**Submission for Compliance with Approval Condition (d) -  
the Submission of a Drainage Proposal**

**Proposed Temporary Shop and Services for a Period of 5 Years  
and Filling of Land in "Village Type Development" Zone,  
Lot 591 RP (Part) in D.D. 112, Shek Kong, Yuen Long**

**(Application No. A/YL-SK/292)**

**Appendix I – Response to Comments of the Chief Engineer/Mainland North, Drainage Services Department (CE/MN, DSD)**

Fig.1

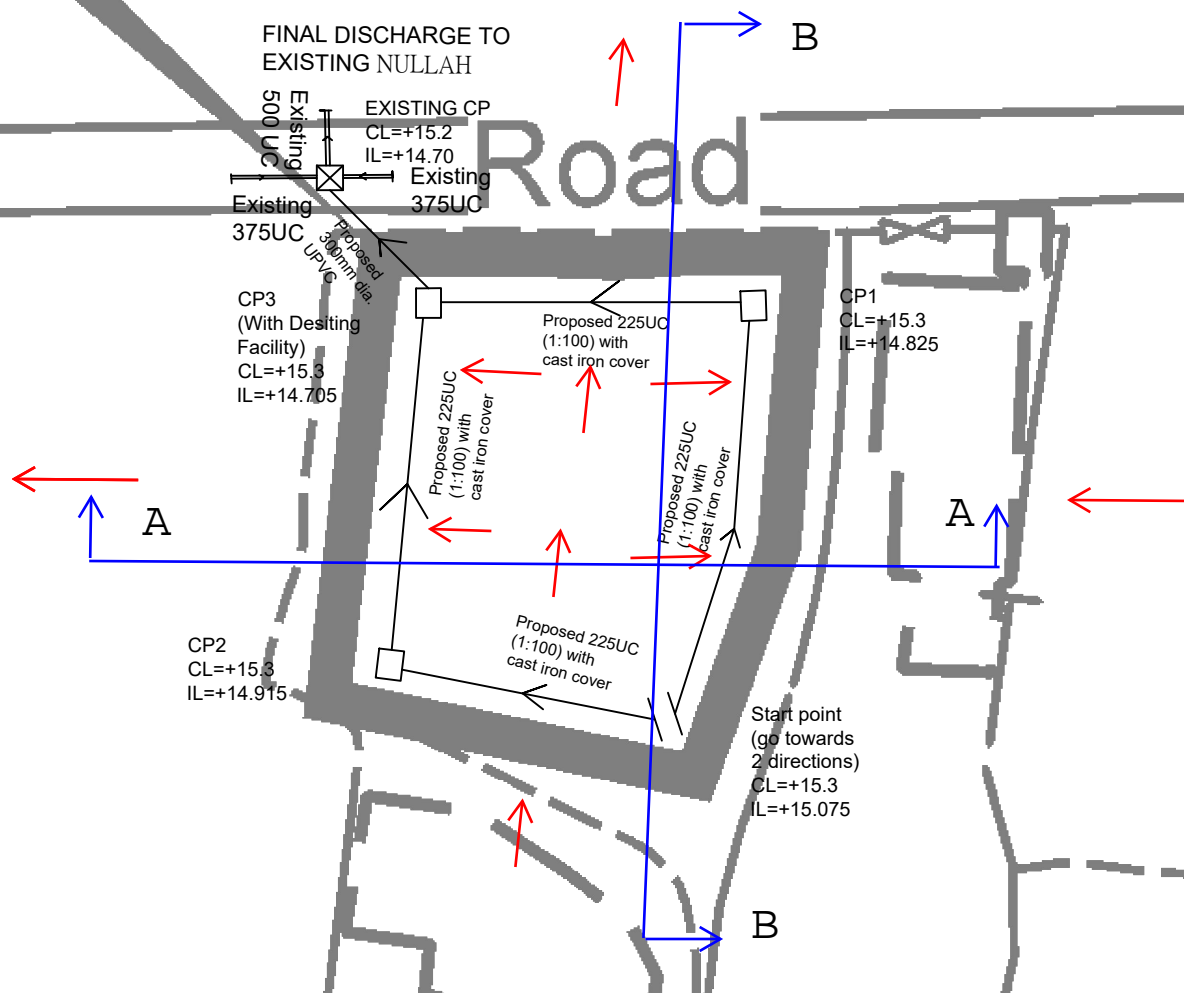
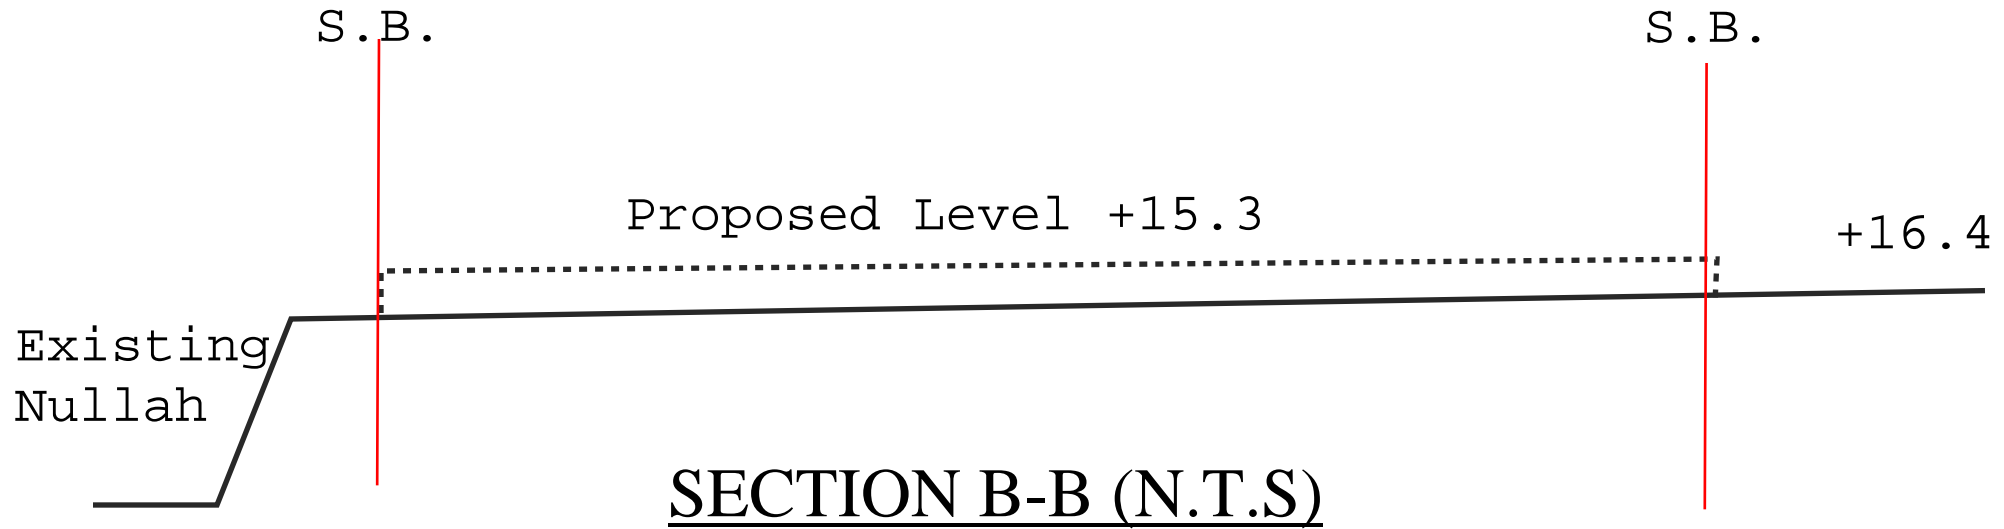
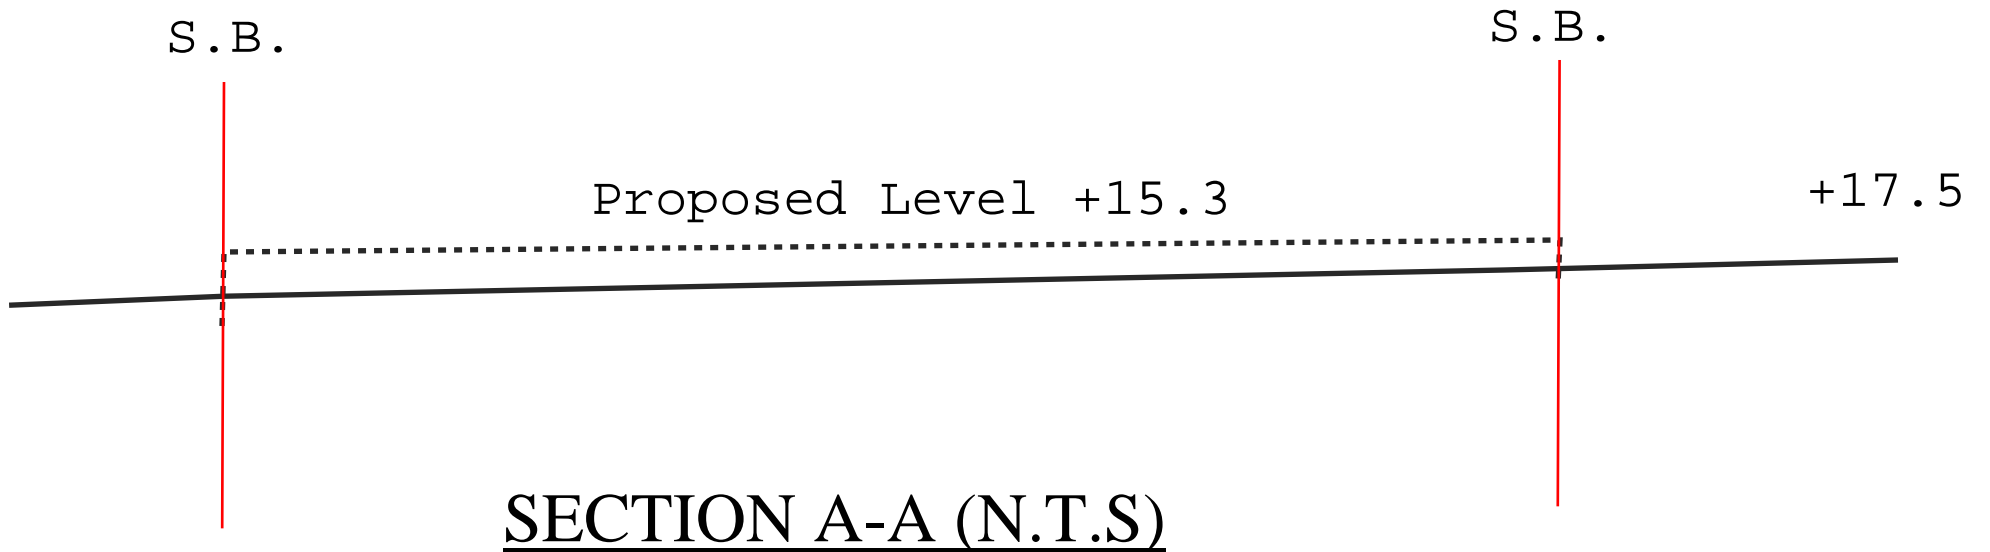
| Comments of the CE/MN, DSD<br>(Contact Person Ms. Vickt SY; Tel: 2300 1347) |  |  |
|---|--|--|
| (ii)  | The proposal should indicate how the runoff (the flow direction) within the site would be discharged to the proposed u-channel;  | Flow direction in Fig.1 is provided for reference <b>(Appendix II)</b> .   |

**EXISTING CP - CONNECTION DETAIL**

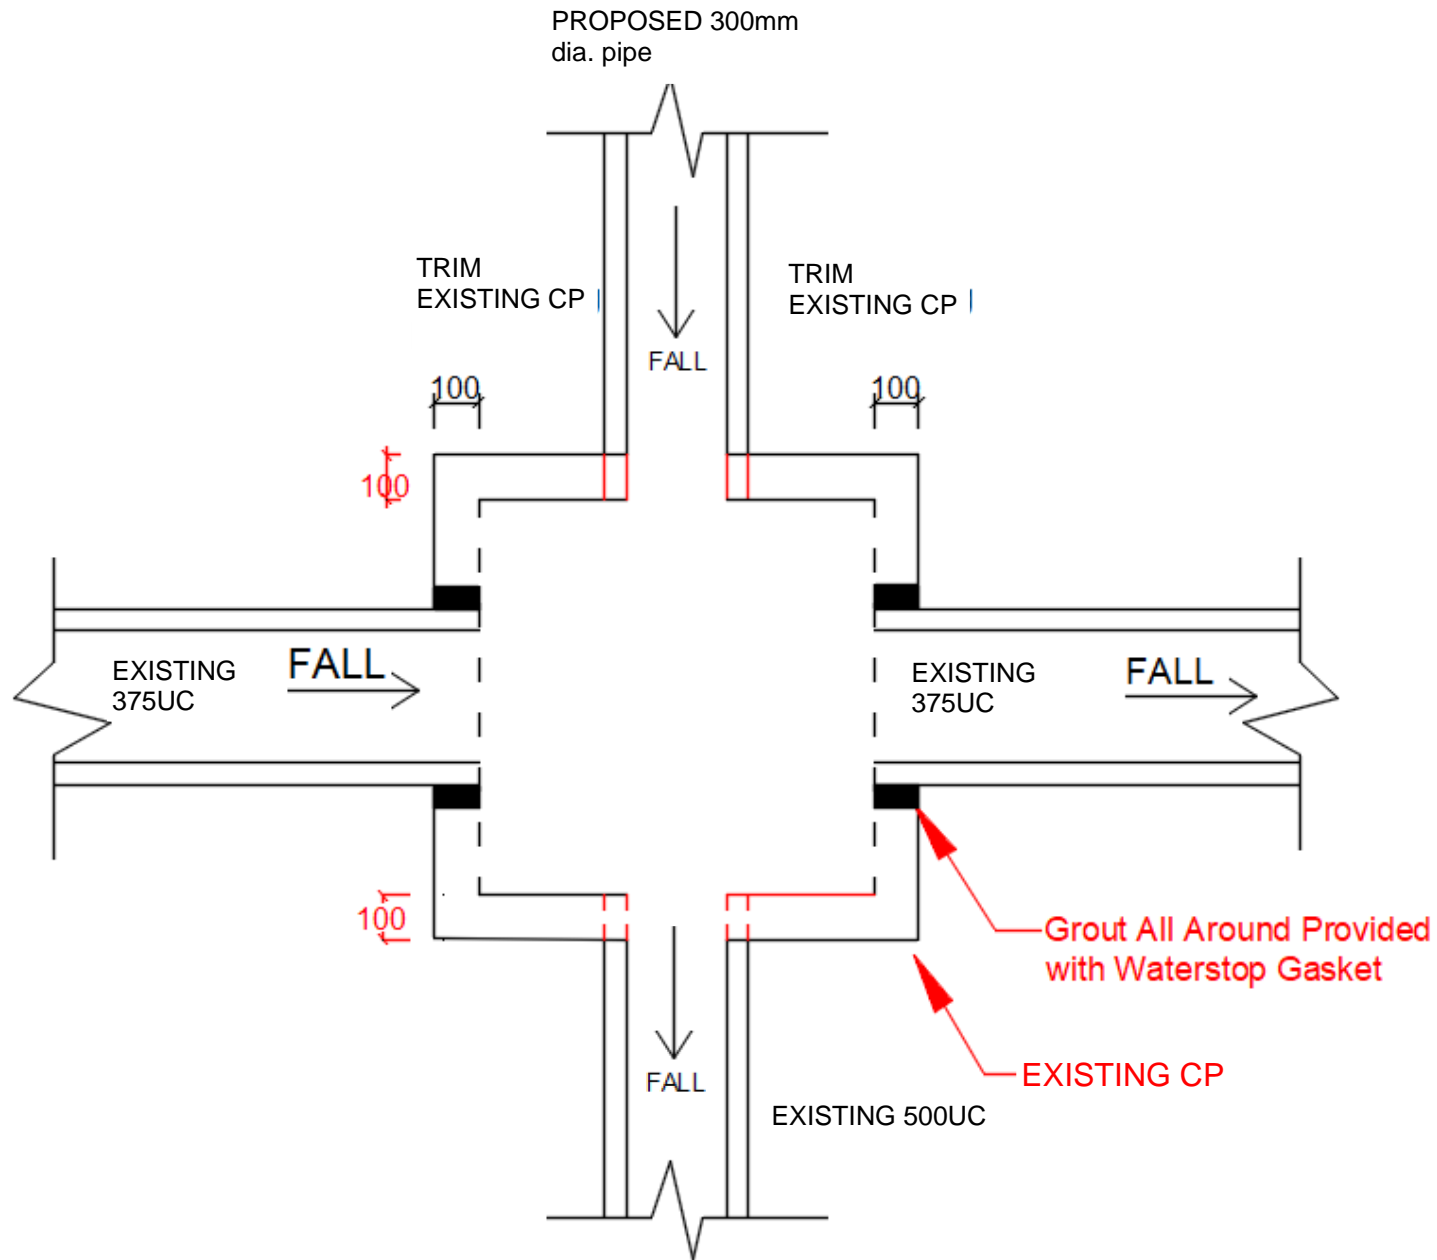
| Comments of the CE/MN, DSD<br>(Contact Person Ms. Vickt SY; Tel: 2300 1347) |  |  |
|---|--|--|
| (iii)   | Cross sections showing the existing and proposed ground levels of the captioned site with respect to the adjacent areas should be given;   | Cross-sections showing the existing and proposed ground level are provided for your consideration <b>(Appendix II)</b> . |
